SUBJECT: COMMENTS ON A DPV CONCERNING EARLY BLOWDOWN CLADDING
RUPTURE DURING A LARGE BREAK LOCA

Comments on a DPV Concerning Early Blowdown
Cladding Rupture During a Large Break LOCA

SUBJECT: DFV CONCERNING CONTAINMENT ISOLATION VALVES AT ZION

FIGURE 1. Nominal CSAU Case

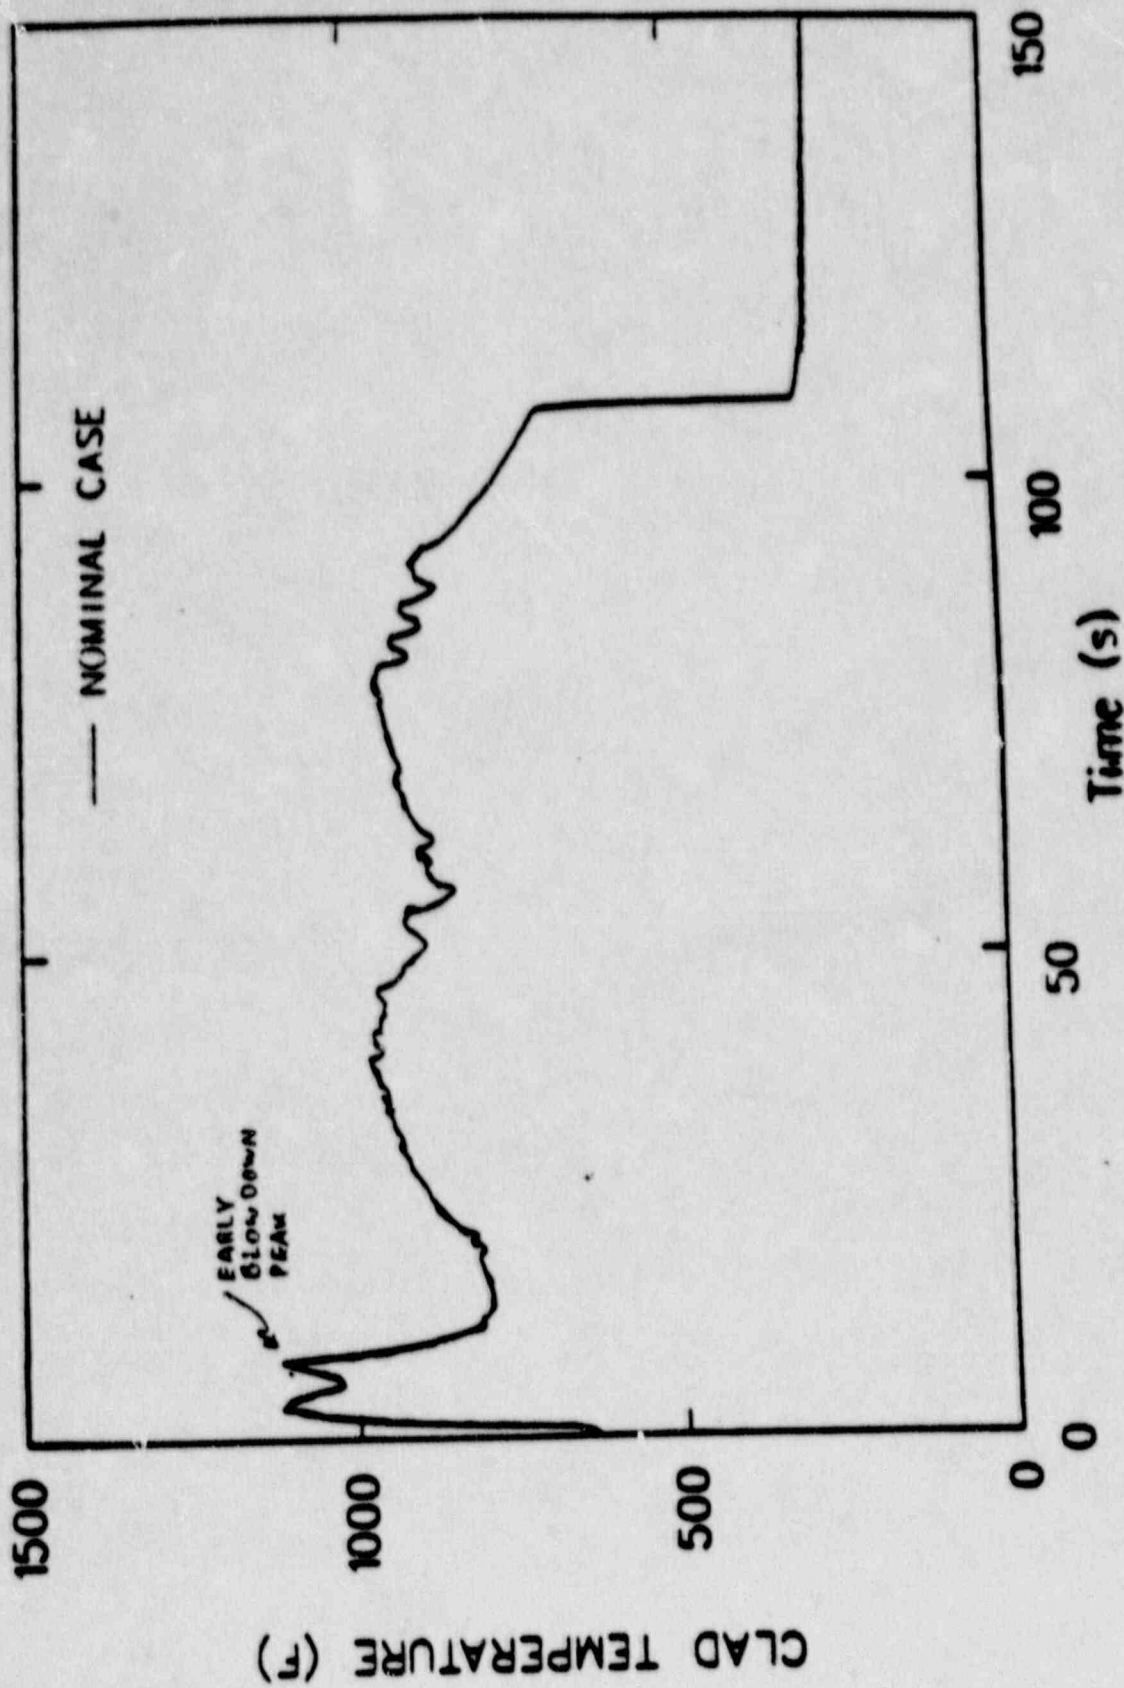
1750°F is indeed a very high early blowdown peak cladding temperature (PCT), but virtually impossible for a high burnup pin with a much lower PLHGR. If a high burnup pin reached 1750°F, at 7 seconds it would most likely rupture. More realistic, LOCA analyses have been performed as part of the Code Scaling, Applicability, and Uncertainty program in RES. A best estimate analysis was performed and code uncertainties evaluated for a large break LOCA (reference 2). In order to accomplish this, sensitivity studies were performed which varied gap conductance, peaking factors and several other variables. The plant used was a Westinghouse 4-loop 3411 Mwt plant with 17x17 fuel and a low burnup of only 16000 MWD/MTU which resulted in a PLHGR of 9.35 kw/ft. The blowdown peak for the nominal CSAU case was 1103°F (see figure 1). Based on over 250 clad temperature calculations and using Monte Carlo sampling techniques, it was determined that the 95th percentile blowdown PCT was 1447°F. It has been determined that 15x15 pins (as used at Zion) with burnups greater than 40,000 MWD/MTU have PLHGRs no greater than 5.17 kw/ft. Using the CSAU calculated sensitivity of blowdown PCT to LHGR, the value of 1447°F can be extrapolated to approximately 1265°F for the 5.17 kw/ft PLHGR high burnup 15x15 pin. This illustrates that the 1750°F blowdown PCT calculated by Westinghouse is quite conservative, especially for a high burnup pin. I believe that this Westinghouse calculation is probably at least 10 years old.

Figure 2. Comparison of measured and calculated fuel rod plenum pressure versus time for Rod 3 of PBF test LOC-3.

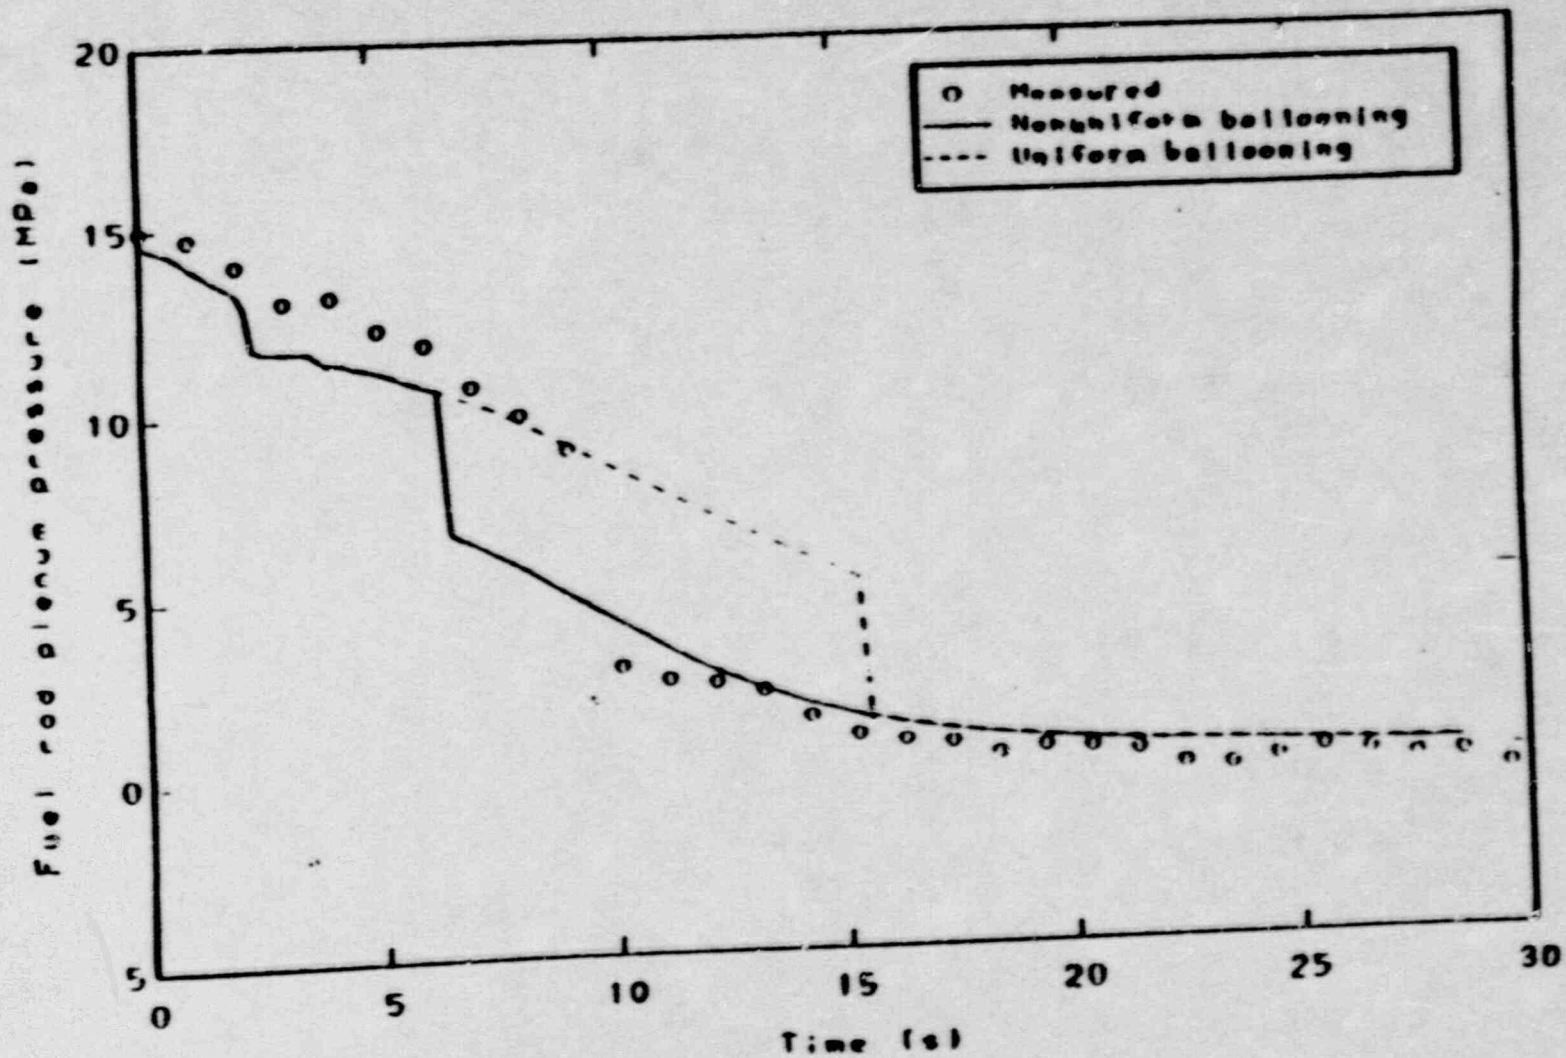
The basis for concluding that pin pressure increases during an LBLOCA blowdown is not known and contrary to the evidence. A series of 3 large break LOCA simulations (reference 3) (LOC-3, LOC-5, and LOC-6) were performed in PBF with well instrumented Zircaloy clad UO₂ fuel elements pre-pressurized to simulate low and high burnup PWR fuel. PBF blowdowns are quite severe compared to postulated PWR LBLOCA blowdowns. In PBF, the pressure decrease and rate of mass loss is very rapid. No good reverse flow blowdown heat transfer is evident as is the case in LOFT results or PWR analysis. Figure 2 (reference 6) shows the fuel rod pressure for rod 3 in test LOC-3. Also, shown are FRAP-T6 calculations using two different plastic deformation models. Clearly, pressure decreases throughout the transient. Figure 3 is a plot showing measured pressure decrease for Rod 11 in Test LOC-6. A FRAP-T6 characterization calculation was done for a postulated LBLOCA in Zion (reference 7) which also showed a pressure decrease throughout the transient.

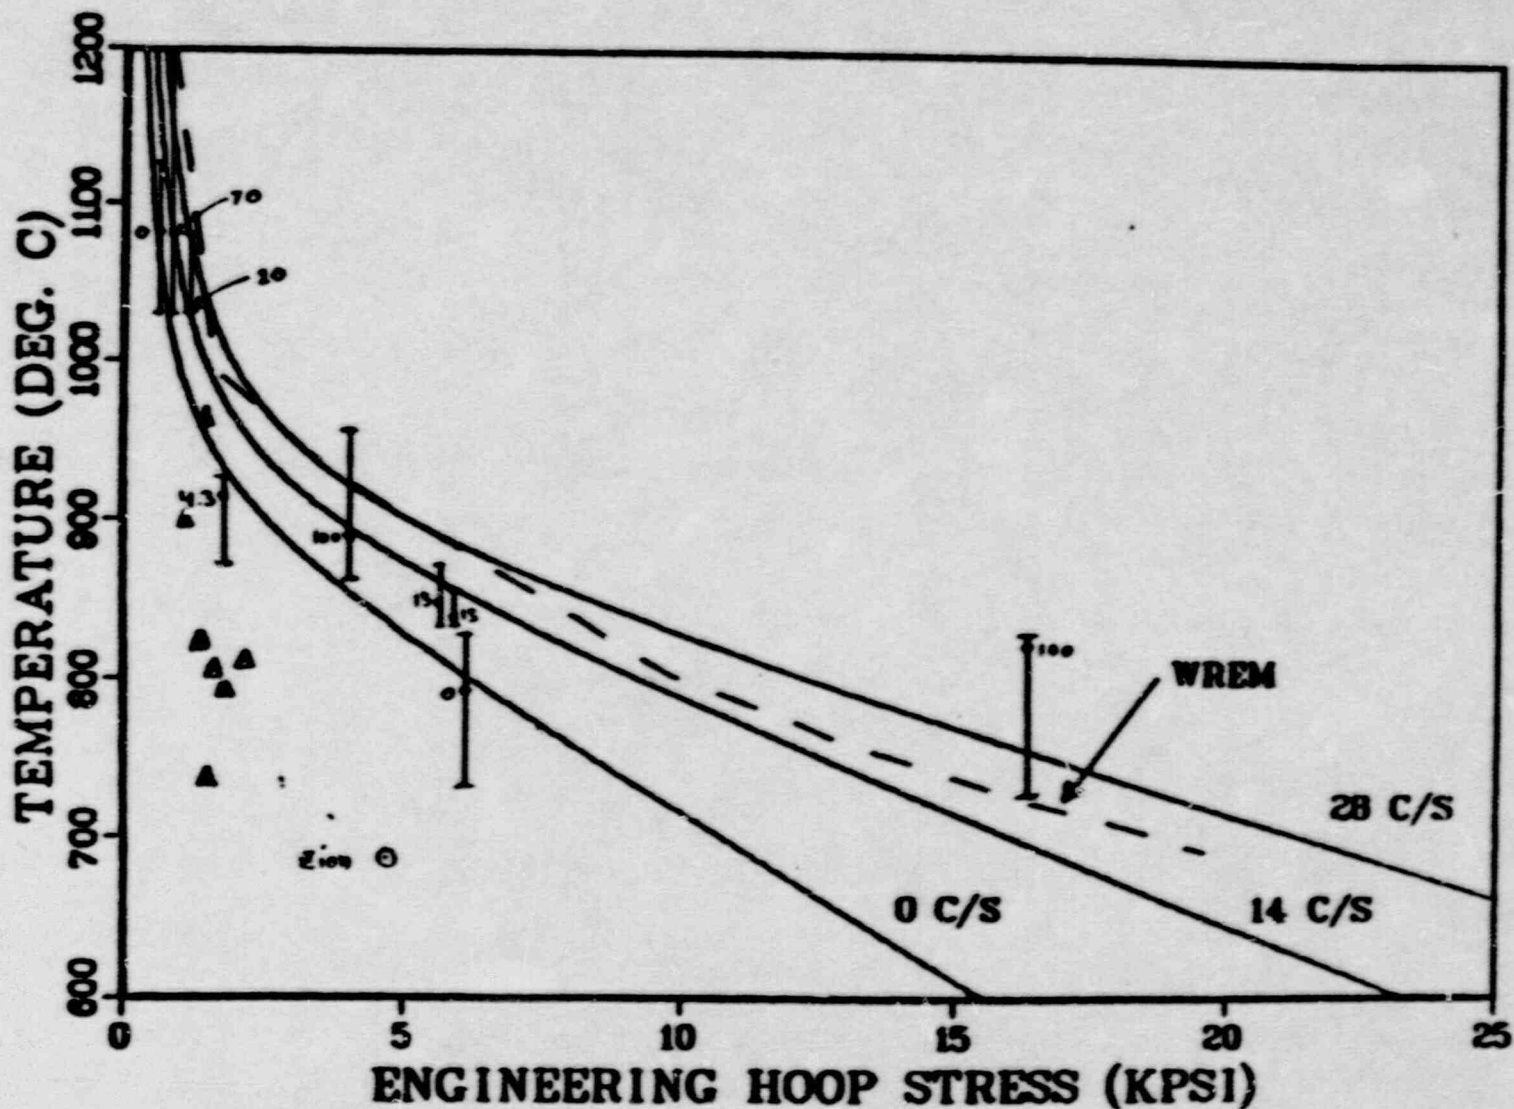
It is clear that TREAT data is anomalous compared to the electrically heated rods and is attributed to difficulties in obtaining accurate temperature data in the burst region. A better source of in-reactor data is the PBF series discussed previously. Figure 4 is a plot from NUREG 0630 (reference 8, exhibit 16). Included are data points with temperature uncertainty for the 9 ruptured rods in the PBF LOC series of tests, and the FRF data from TREAT. It is clear that the more recent PBF data is very consistent with the NUREG-0630 curves.

As noted earlier, the CSAU 17x17 95th percentile PCT of 1447°F (reference 2) could be approximately extrapolated to 1265°F for a high burnup 15x15 pin. The 15x15 PCT calculated at 13.26 kw/ft (reference 7) was 1543°F. The Zion hot pin did not rupture in reference 7. The reference 7 calculation extrapolated to 5.17 kw/ft would result in a PCT of about 1187°F. Therefore, 1265°F determined previously appears to be a good high side estimate of blowdown PCT for a high burnup 15x15 pin. In both reference 7 and reference 2, this blowdown peak occurred between 5 and 9 seconds.
